PLANNING COMMISSION MEETING

August 7, 2023
4:00 PM

AGENDA

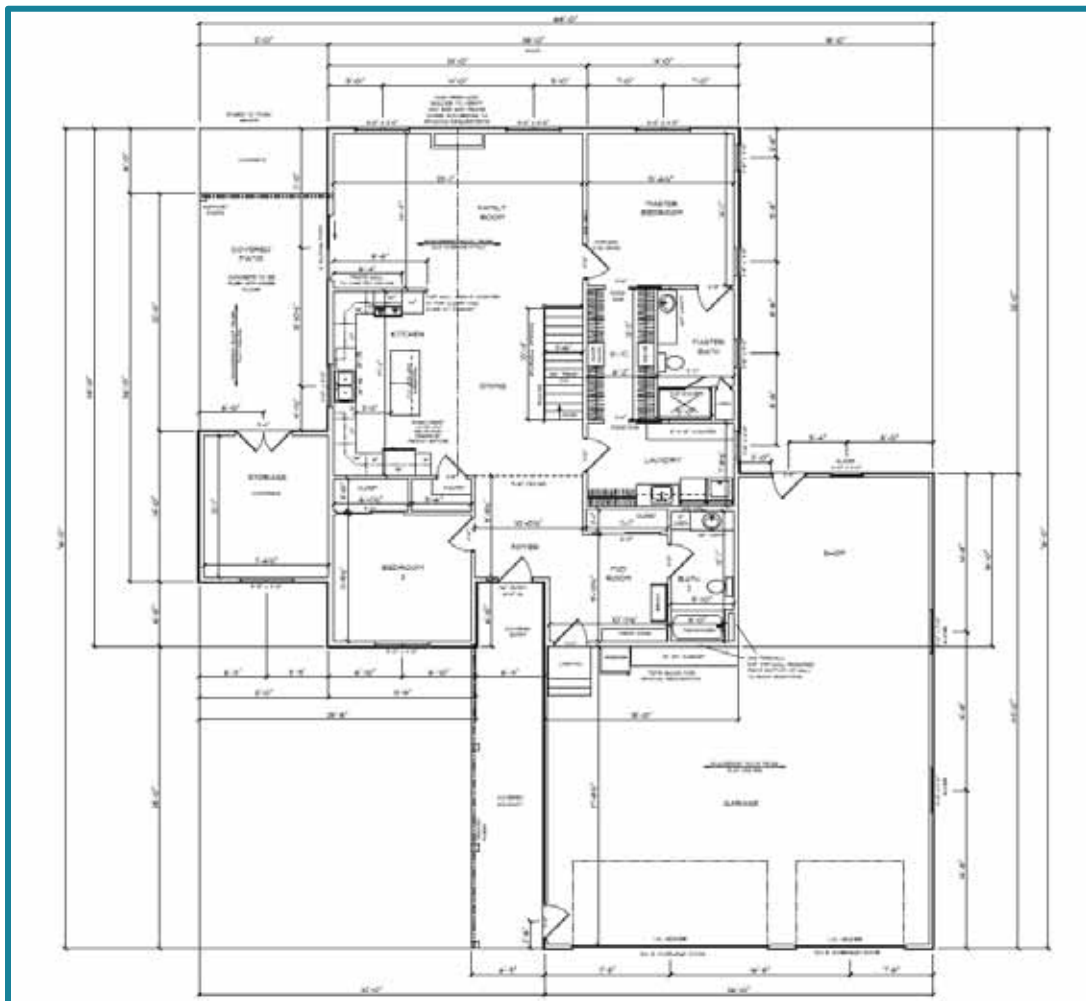
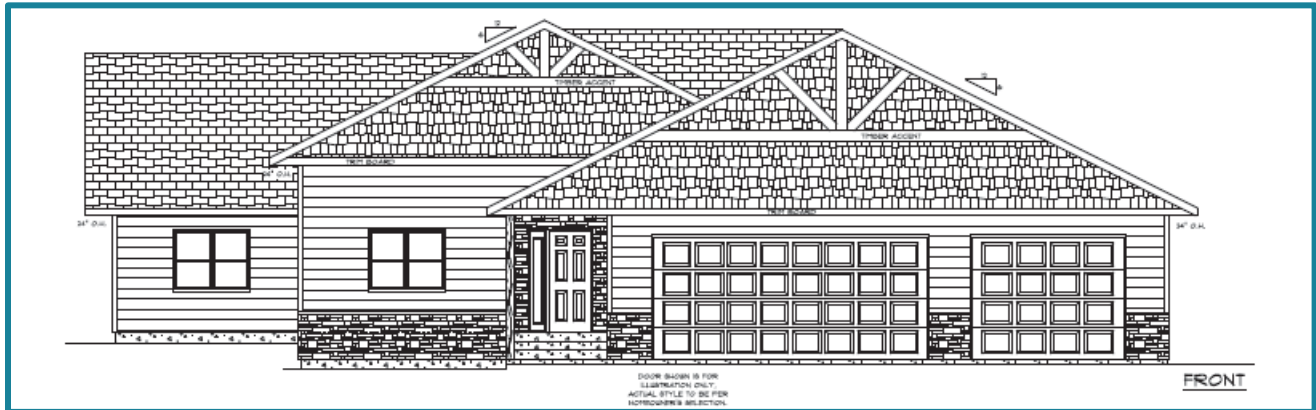
The applicant is requesting a special exception to exceed the floor area of attached garage maximum in the Mixed Residential (R-2) District. The applicant has completed building plans and is working to secure a building permit with the City. The desired plan for the single-family dwelling is to construct a 1,786 square foot home and a 1,268 square foot attached garage and workshop. When preliminary drawings were submitted for review, staff noted that the garage was in excess of the 50 percent maximum rule which in this case would limit that attached garage to no more than 893 square feet. The minimum required garage for a single-family home in the City is 400 square feet.

Floor area of attached garage, maximum	s. 11.06.112	50 percent of ground floor living area; the Planning Commission may allow more than 50 percent as a special exception provided the floor area over 50 percent is deducted from the allowable floor area of detached accessory buildings
--	--------------	---

Several decades ago, front porches were the primary design elements of a home and contributed to more walkable, community centered neighborhoods. Over time, garages rather than porches have become the primary design element of homes as development has become more automobile centered. The 2018 Chapter 11 – Zoning revision likely included the maximum garage standard to ensure that attached garages were subsidiary to the home and not the

dominating feature of new single-family residences. The standard also helps to ensure that new home design contributes to more walkable, community-oriented neighborhoods.

Arguably in this case the garage does not dominate the front façade of the single-family residence. Since the garage has substantial depth, the overall aesthetic contains a desirable balance of a single-family residence with an inviting landing and design elements with a proportionate attached garage.

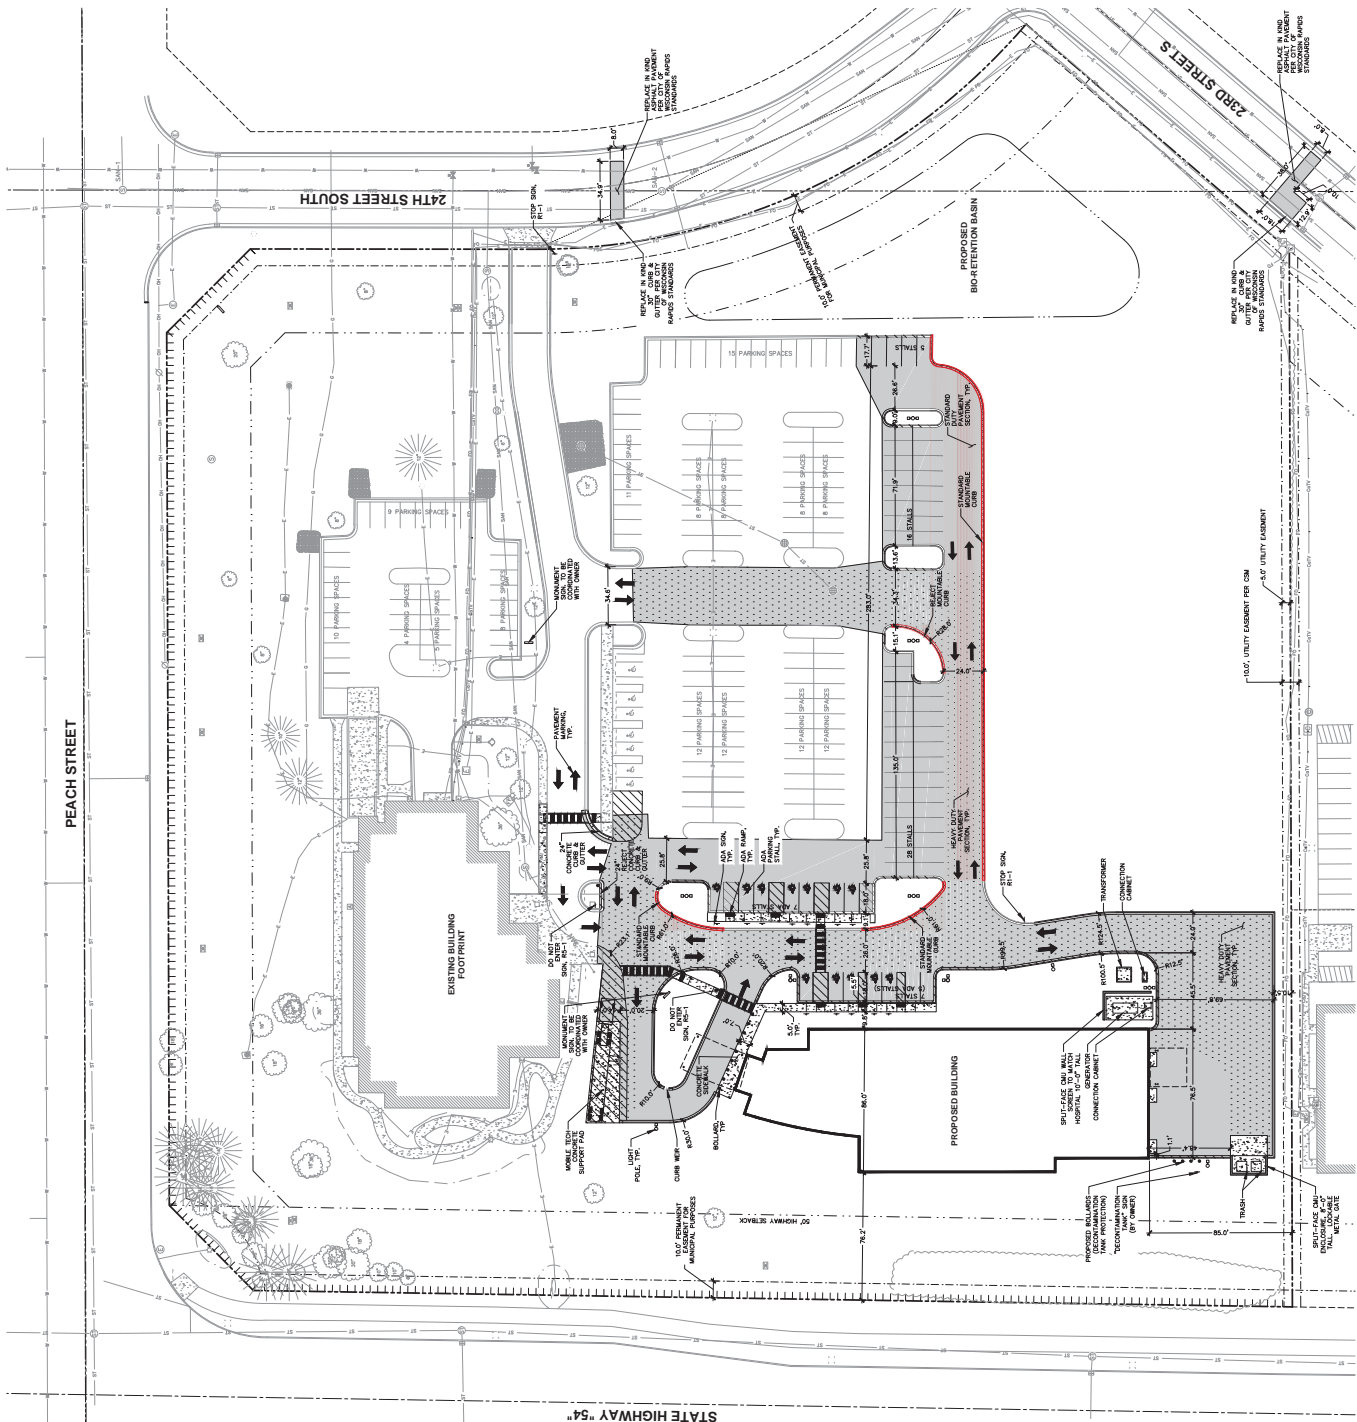
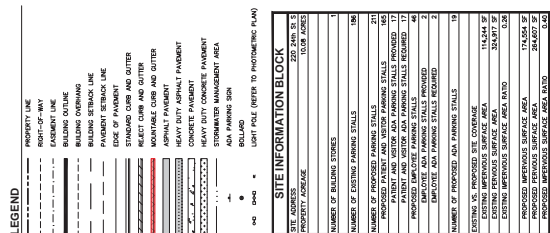
- **Parking lot landscaping:** With the expanded areas, approximately 585 landscape points are required. The original landscaping plan identifies 741 landscape points, meeting this requirement.

Findings: The applicant submitted an updated landscaping plan prior, which exceeded the new required parking lot landscaping amount. This standard is met.

Analysis: No changes to the building are proposed.

Findings: No architectural review is required.

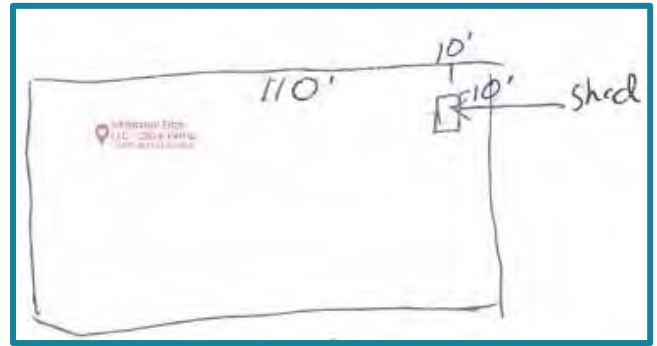
Analysis: A retail business of 10,000 square feet or less is permitted within the General Commercial “B-2” Zoning District. The use is existing, and an accessory structure is proposed onsite.

Findings: Note that a building plan – architectural review (AR), site plan review (SP), and zoning permit (ZP) are required.

1. The accessory building shall be placed on a stable foundation and anchored appropriately, to be approved by the Community Development Department.
2. Applicable permits through the City shall be obtained.
3. Community Development Department staff shall have the authority to approve minor modifications to the plans.
